CITY OF MERCER ISLAND

RE: SEP18-021 – Request for Information 1

Re: Comments Upon Request for a SEPA Threshold Determination relative to construction of a new single family residence on a vacant lot including a stormwater conveyance crossing a Type 3 watercourse

DSG File #: SEP18-021
Applicant/Owner: Paul Maksimchuk/Four Seasons Homes LLC
Location of Property: 4634 E. Mercer Way, Mercer Island, WA 98040
King County Tax Parcel: 755870-0008
Other Associated Permits: CAO17-007 and 1507-166REV

Figure 2: Site Topography (Data Source: King County 3x3 Digital Elevation Model)

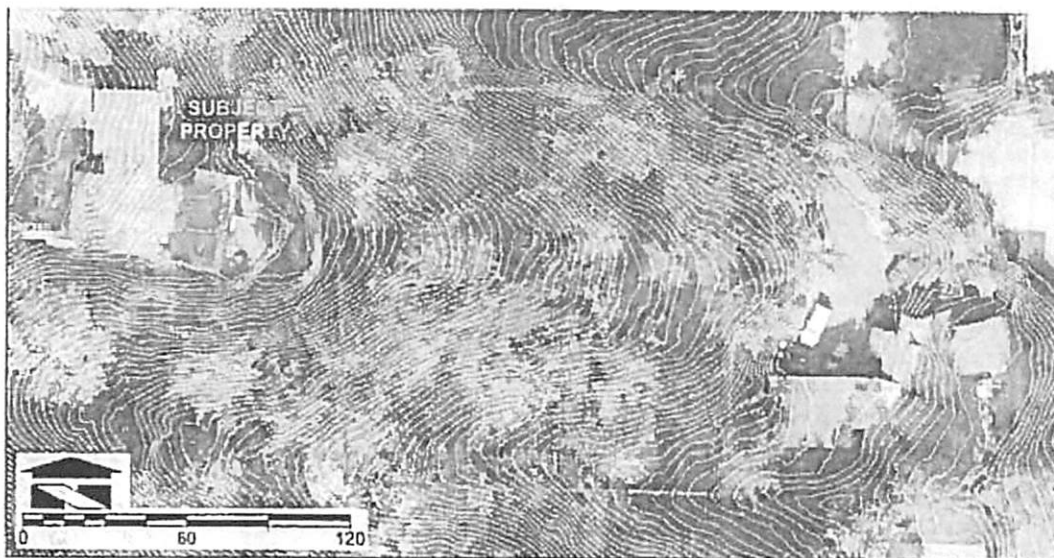
The project requires one crossing of the aforementioned seasonal stream channel. An ABS stormwater pipe will be elevated from the ground surface in the vicinity of the watercourse using pipe collars. This approach will limit impacts to stream function. *Too small of pipe to handle 100 year Flood Plan and will dump water onto the lowest point on our property.*

Existing drainage patterns are in the form of sheet flow to the south and east, towards the seasonal channel and Lake Washington. This proposal alters drainage patterns by collecting and conveying the developed drainage and surface inflow generated within the project area (~6,000 square feet) directly to Lake Washington. *Directly? See above statement. Pipe is way too small and needs to go directly into Lake Washington*
